Statement

Product Name: LTE Module

Model Number: EC21-A_R1.0, EC21-A_R2.0

EC21-A_R1.0 and EC21-A_R2.0 share the similar HW and SW design, the difference is just as follow:

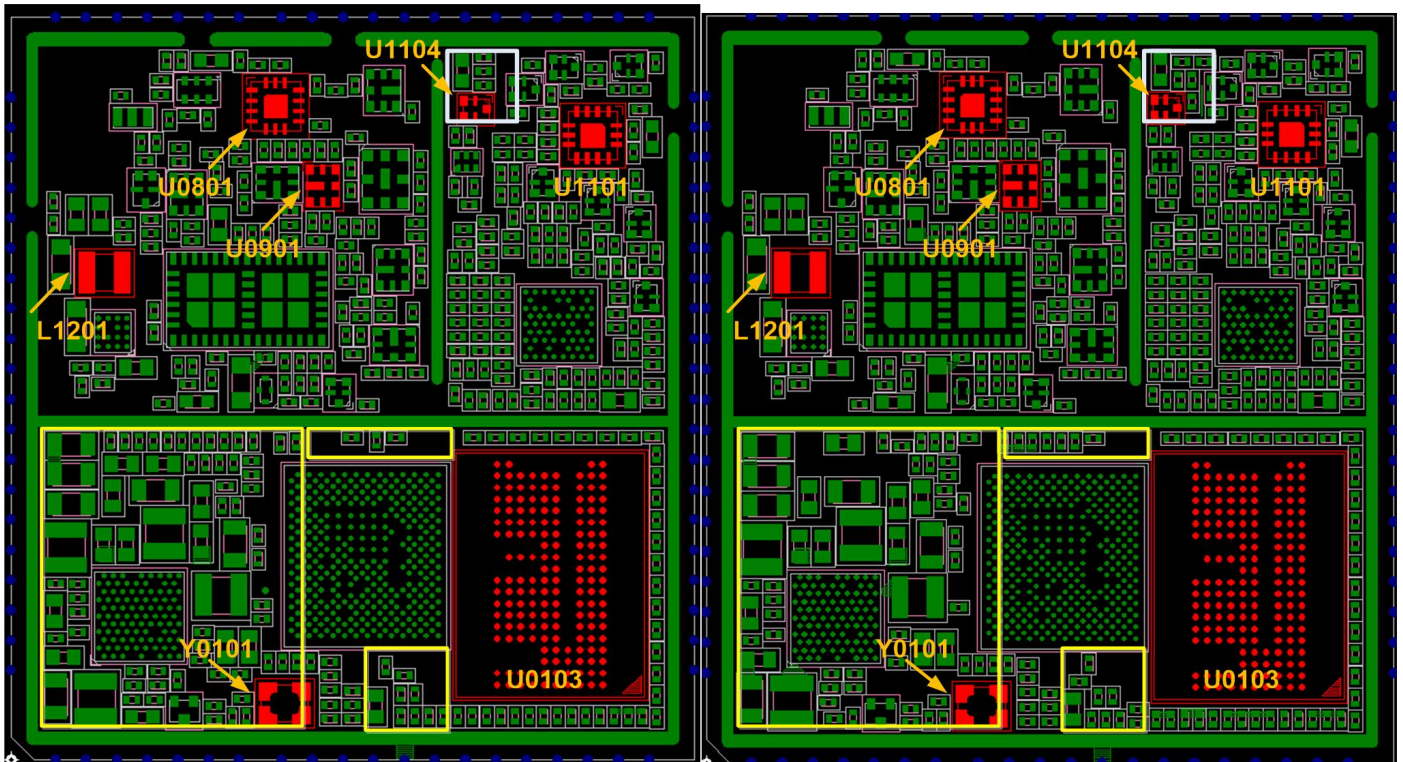
- 1、The manufacturer of Band2 duplex(U0901) is TAIYO for EC21-A R1.0, however the manufacturer of Band2 duplex is MURATA for EC21-A R2.0, The Band2 duplex is pin to pin.

- 2、The MCP chip is FM6BD4G2GXA-1.8BLCGE2K for EC21-A R1.0, and NM1482KSLAXCL-3B for EC21-A R2.0.
- 3、Some reserved or unused resistors near power management unit were removed in R2.0 to improve power delivery network performance, and the corresponding layout (the part circled in yellow) is different.

- 4、The crystal oscillator supplier has been added. The crystal oscillators are pin to pin and share the same frequency.
- 5、The Main RF switch(U0801) supplier has been added. The Main RF switch is pin to pin.

- 6、The Diversity RF switch(U1101) supplier has been added. The Diversity RF switch is pin to pin.
- 7、The GNSS SAW(U1104) supplier has been added. The GNSS SAW is pin to pin. besides, The GNSS circuit added two component in R2.0 to improve power GNSS performance, and the corresponding layout (the part circled in white) is different.
